JURUPA COMMUNITY SERVICES DISTRICT
RIVERSIDE, CALIFORNIA

ADDENDUM NO. 4

**TO THE PLANS AND SPECIFICATIONS FOR
RECYCLED WATER PROGRAM – SEGMENT 2 FINAL DESIGN
JCSD P.N. C215078**

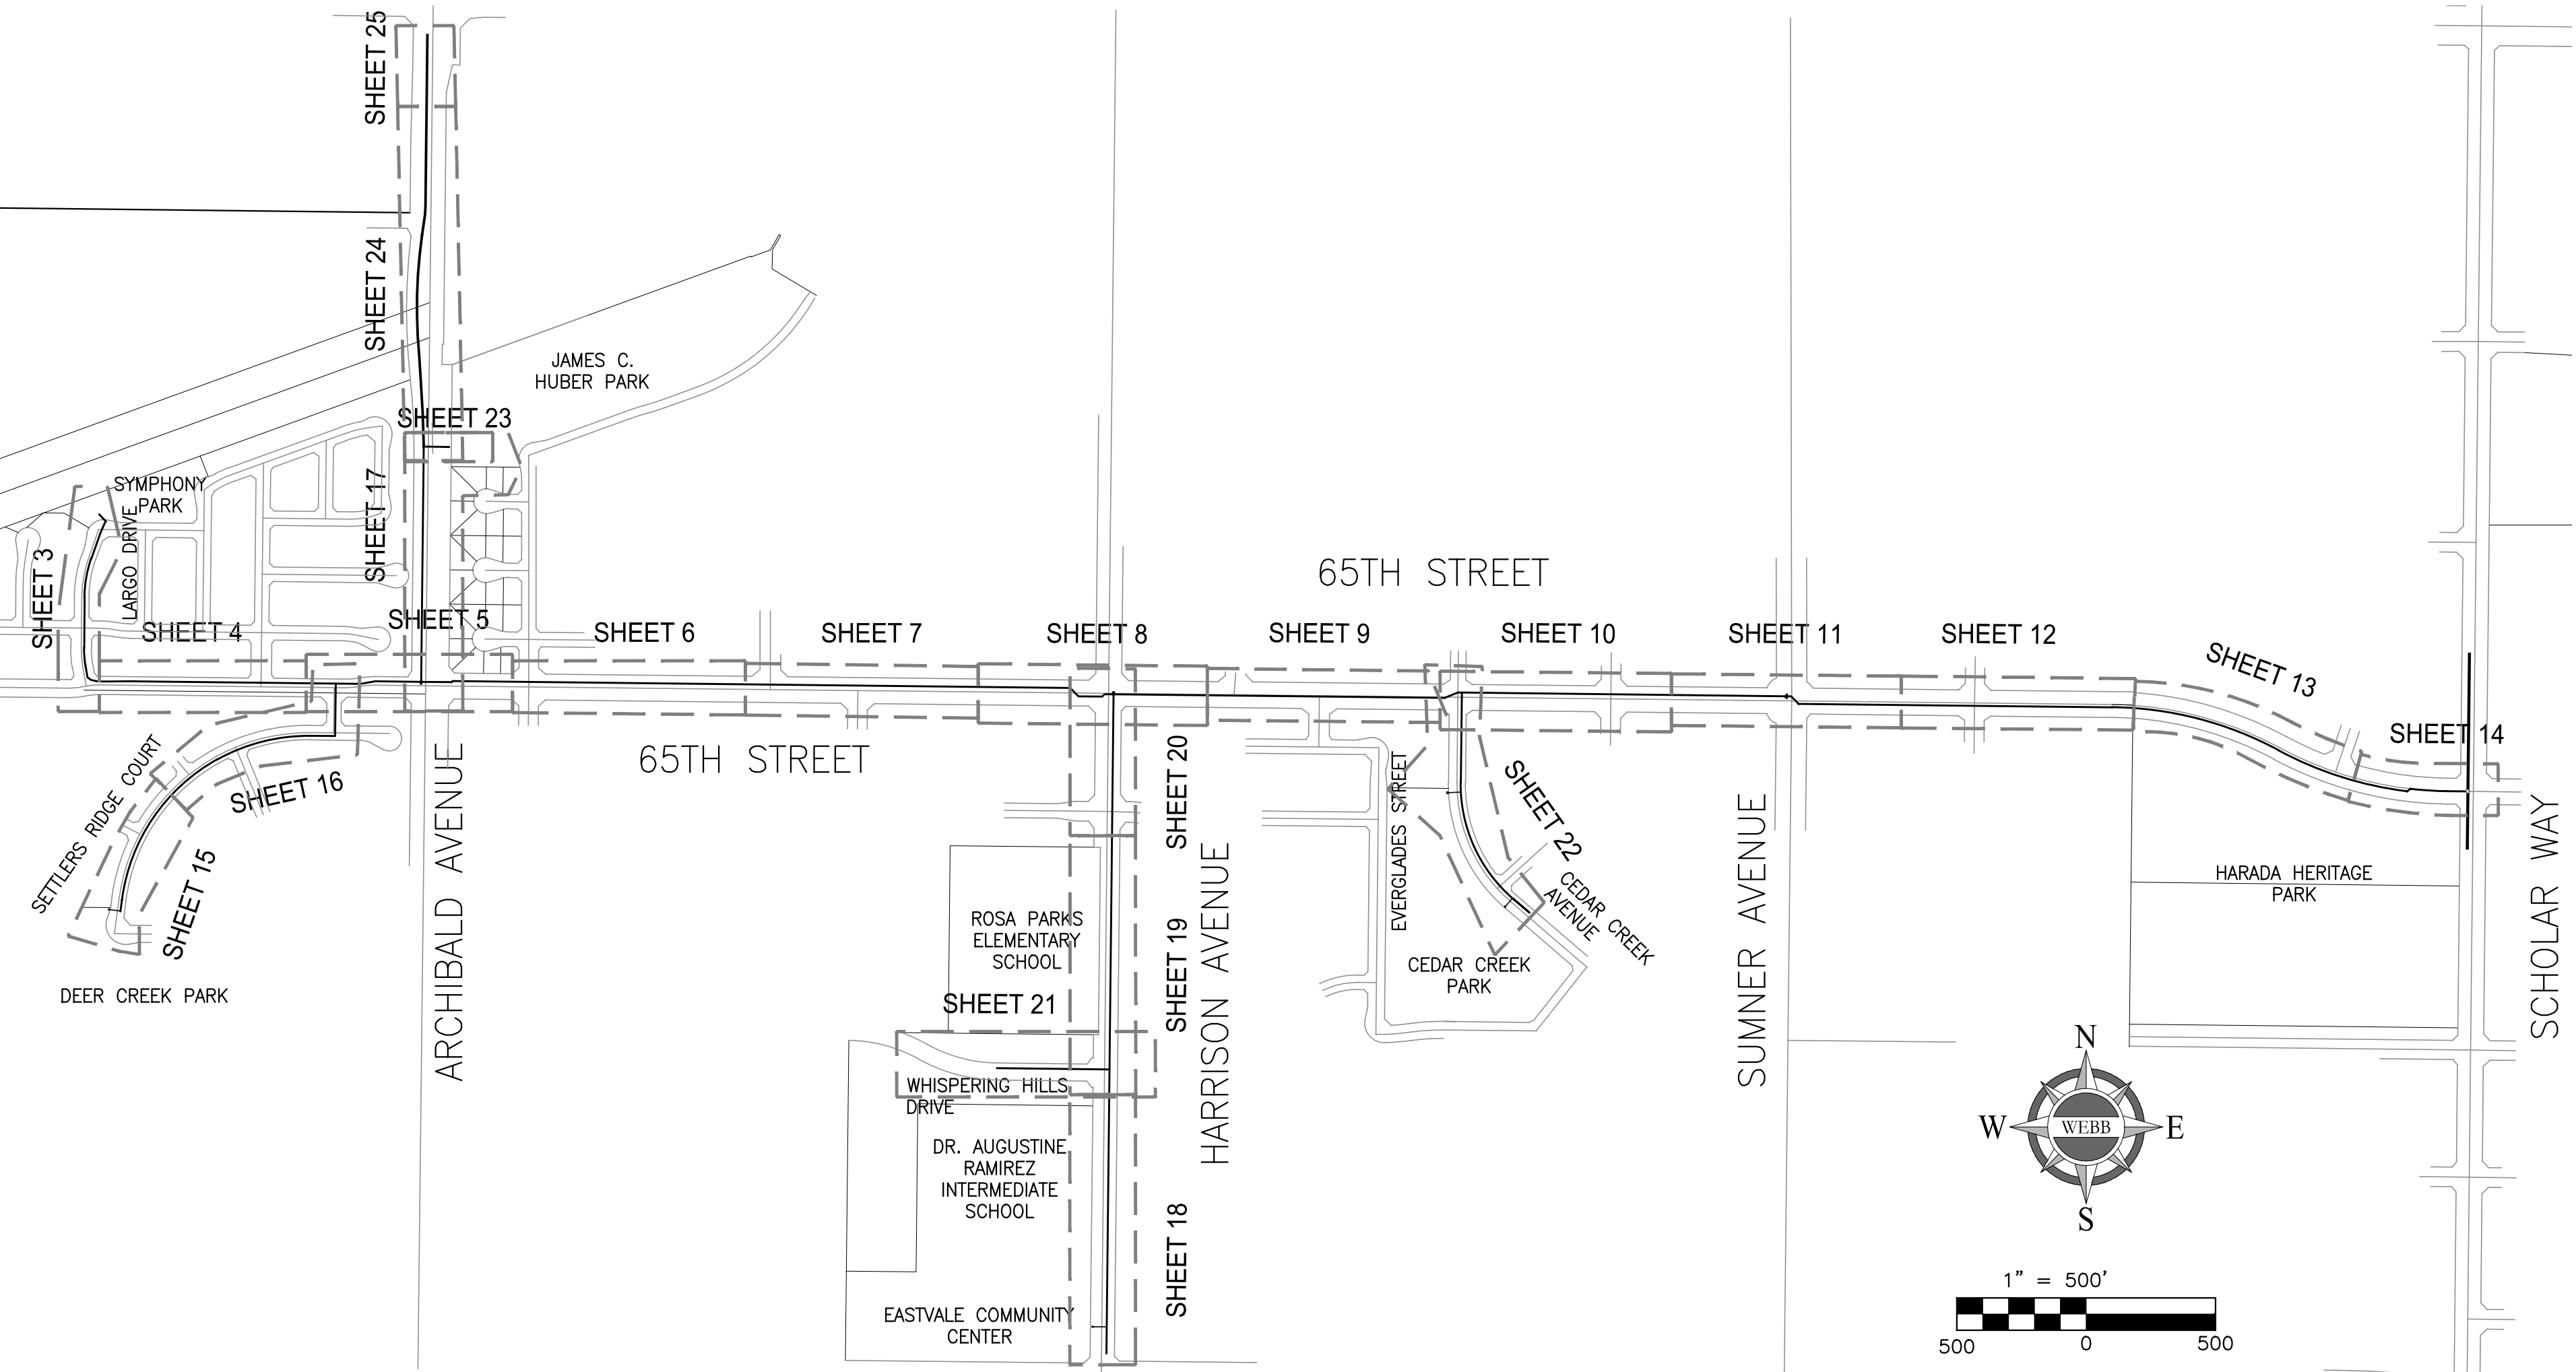
The Construction Notes Index on Sheet 2 has been revised to reflect the use of mechanical joints at bends, rather than the use of flanged fittings at bends with flange to mechanical joint adapters. The revised Construction Notes (Notes Nos. 2, 3, 5, 14, 22, 31, and 32) are indicated on Sheet 2, and where they appear throughout the plan set. Additionally, stationing for Whispering Hills Drive (Sheet 21) has been revised to reflect the new length of the alignment stationing.

Construction Notes No. 19 and 30 and (previously describing 4-inch service laterals and 8"x4" cross, respectively) has been revised to "Not Used".

JURUPA COMMUNITY SERVICES DISTRICT			SHEET NO. 21
CITY OF EASTVALE/JURUPA VALLEY, CALIFORNIA			
JCSD RECYCLED WATER PROGRAM PROJECT			OF 26 SHEETS
SEGMENT 2			
WHISPERING HILLS DRIVE			
STA. 10+00.00 TO STA. 16+02.04			
FOR: J.C.S.D.	W.O. 22-0187	CITY FILE NO. PW22-10010

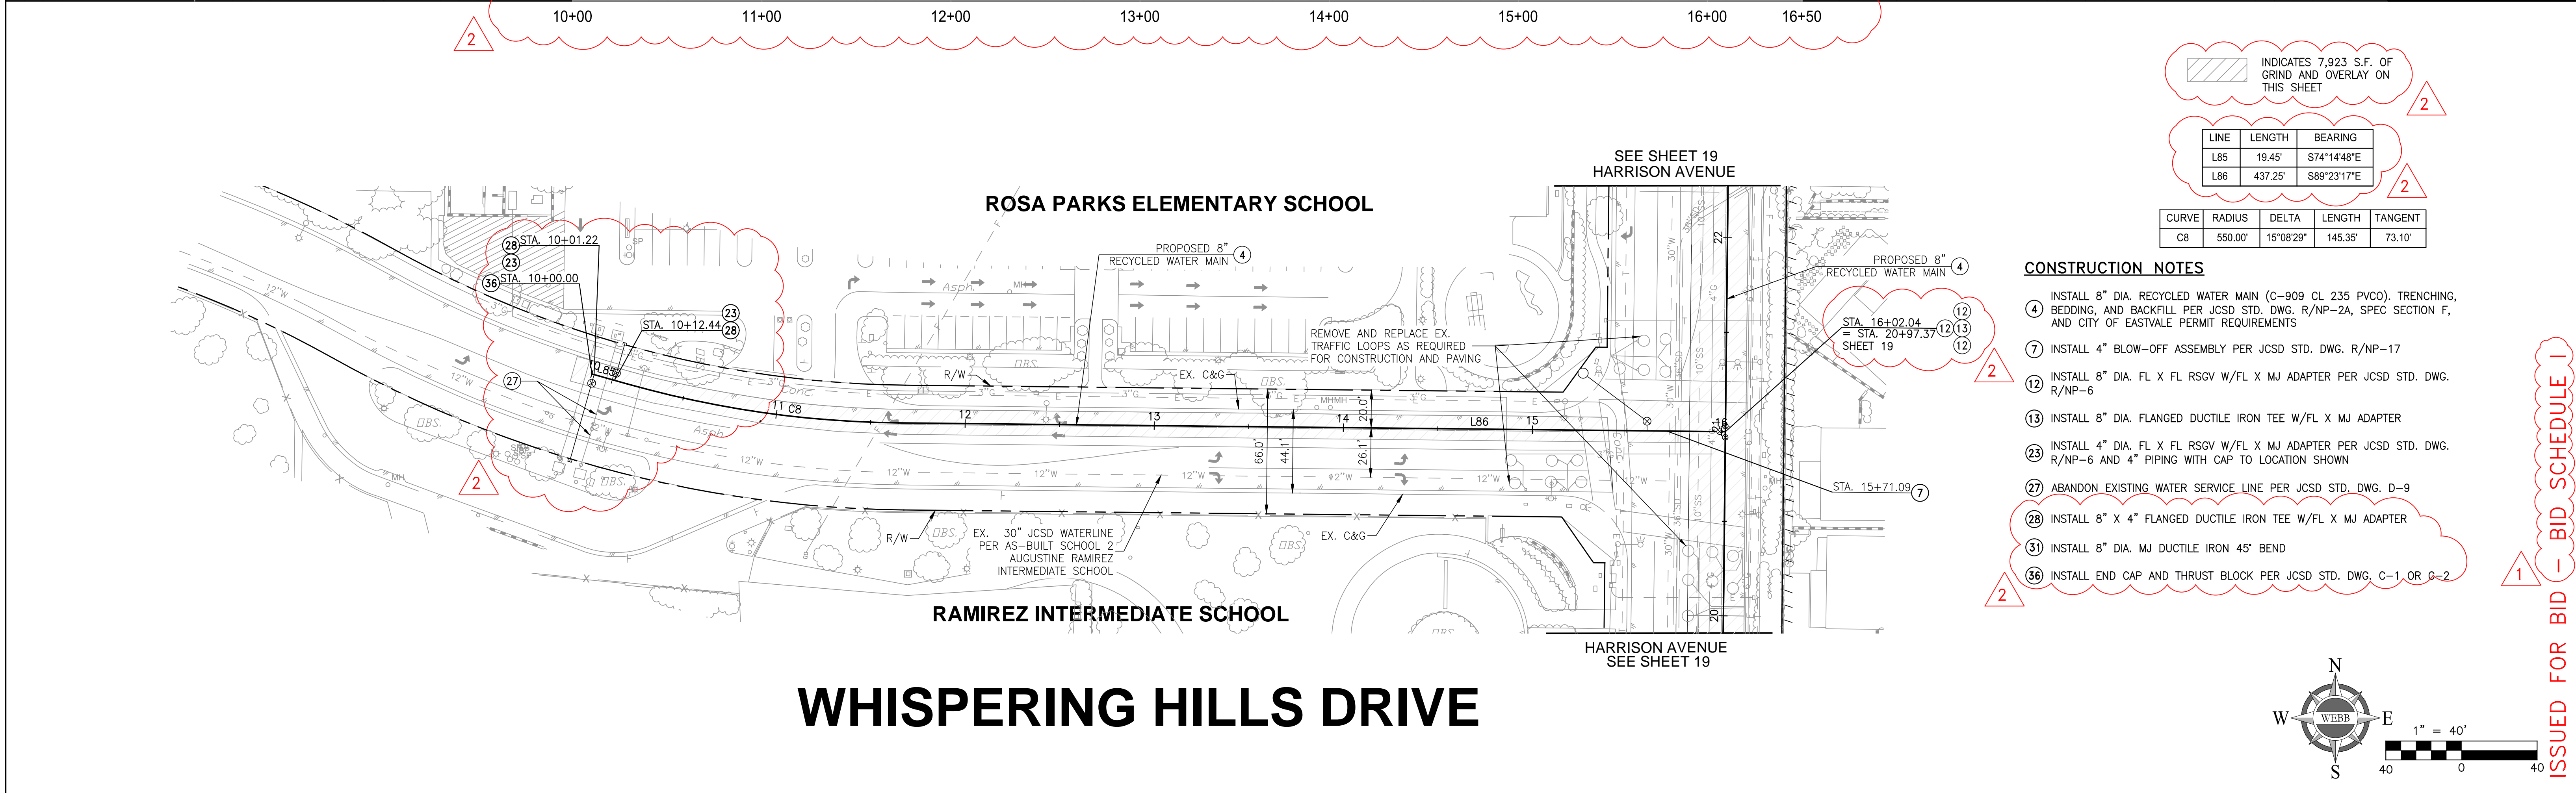
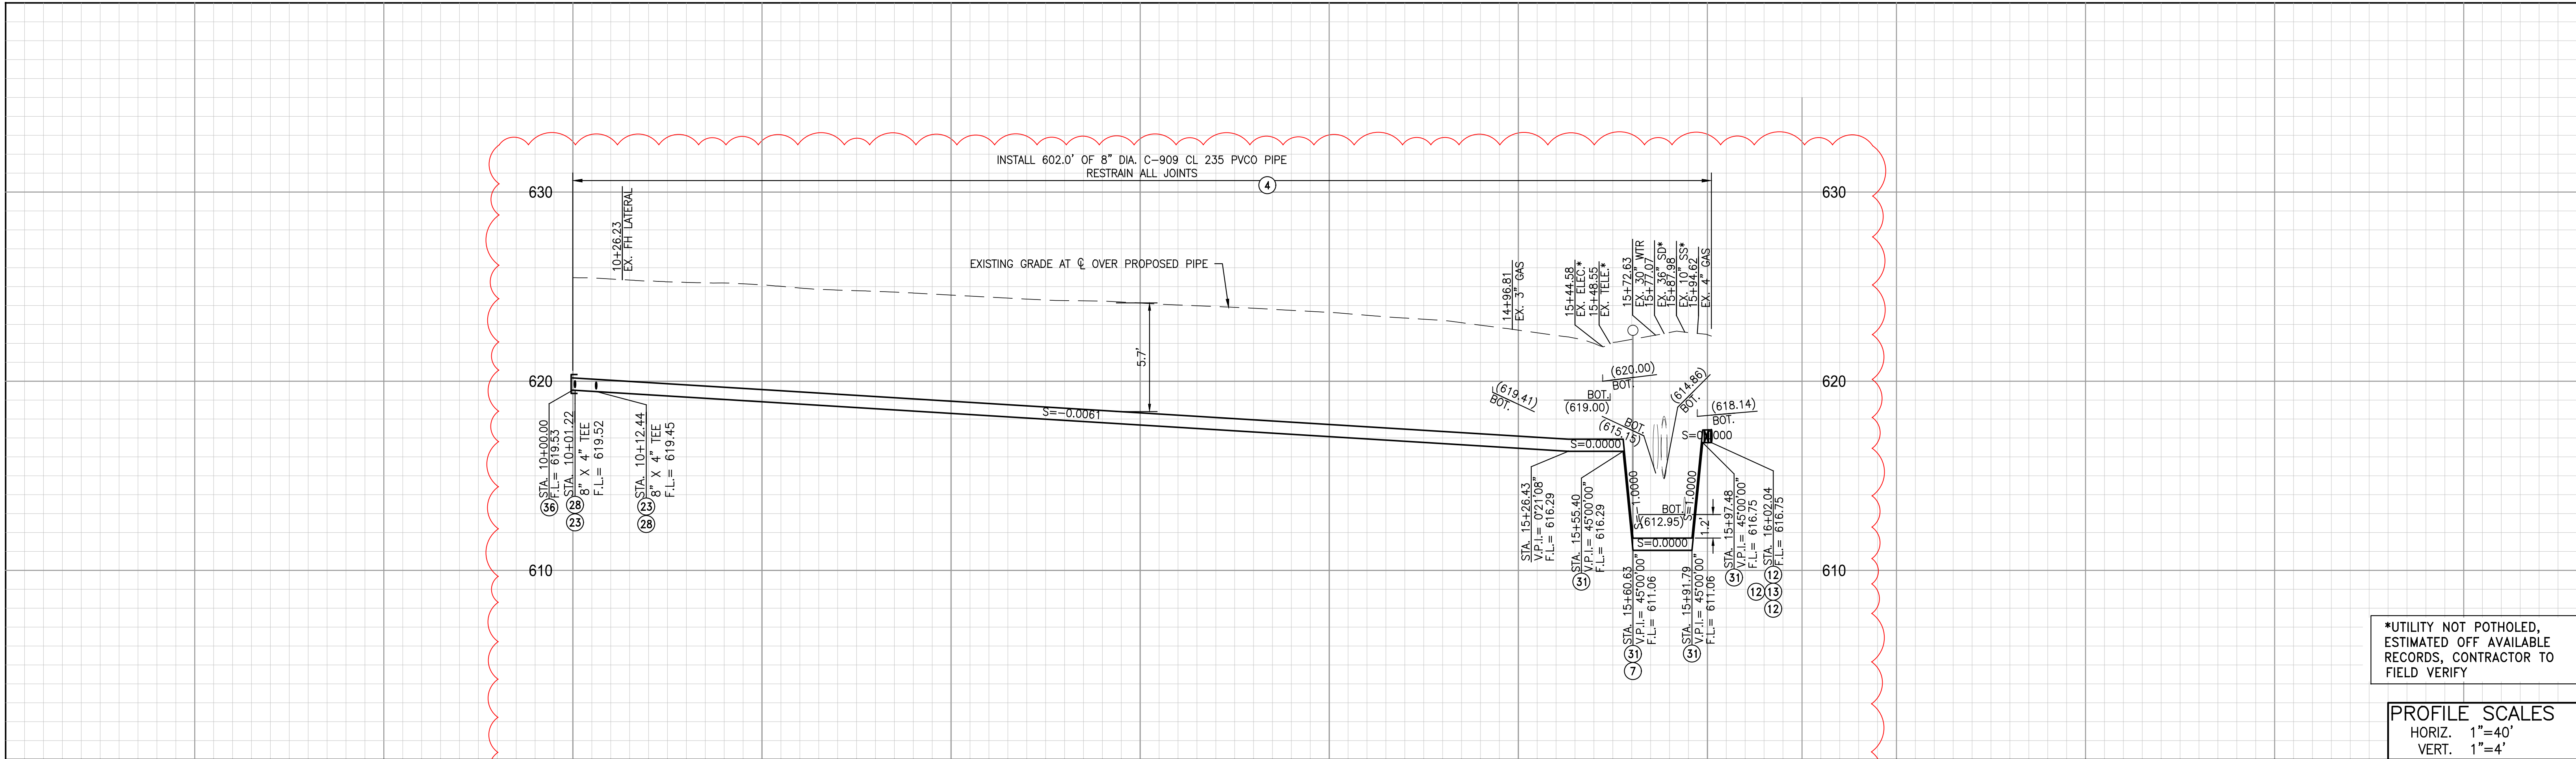
Sheet 21 - The length of the alignment and location of laterals for Rosa Parks Elementary and Ramirez Intermediate School on Sheet 21 (Whispering Hills Drive) have been revised. As a result, stationing has been revised based on the new

length. Similarly, the Sheet Title for Sheet 21 has been revised to account for the revised Stationing. The 2-inch air/vac assembly, previously near the terminus of this alignment has been removed. The use of a single 8"x4" cross for the two (2) 4-inch service laterals on Sheet 21 has been revised to instead use an 8"x4" tee for each of the proposed services.

Bid Item Nos. 104 and 106 have been revised to "6,390 LF" rather than "6,400 LF" to account for the revised alignment on Sheet 21. Bid Item No. 112 has been revised to "4 EA" rather than "5 EA" to account for the removed 2-inch A/V assembly removed near the terminus of the proposed Sheet 21 waterline.
